## CONCLUSIONS AND SUGGESTIONS AFTER EEP-VCF STAFF VISIT AT THE POZNAN ZOO

### **The Bearded Vulture new aviary:**

Picture 2: Two wooden caves are installed in opposite pillar corners. Both nests have a fixed iron leader.

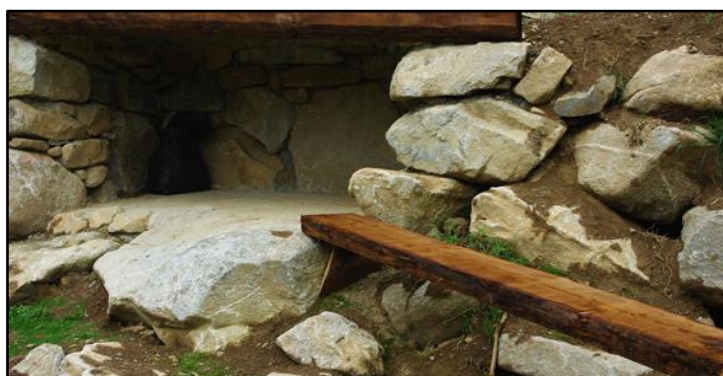
- Bearded Vultures as cliff breeders use small caves in the wild (90-120cm height), and well protected from bad climatology. It is well known that Bearded Vultures by wet nest normally abandon the clutch. It will be necessary to **enlarge (min. 1m) the wooden roof of both caves** for assuring that the nests will be always dry.

- Bearded Vultures as cliff breeders, the perches need to be adapted to suit the anatomy of their feet. For assuring to maintain its balance on it is recommended to install flat perches, around 20cm wide, 4-5cm thick and also need to be rigid enough to prevent them from bending during copulation on the perch. We recommend **to replace the branches -which are installed as perches- by wooden planks.**

Furthermore Bearded Vultures are soaring birds of prey and it is difficult for them, especially for females and older birds, to access perches/nest-platform through flapping flight. For assuring that the birds can climb without problems up to the nest by transporting material or food we suggest to **install the wooden planks in different altitudes.**

firs are very small; to prevent this kind of accidents in the future we **recommend removing them** or changed for small bushes.
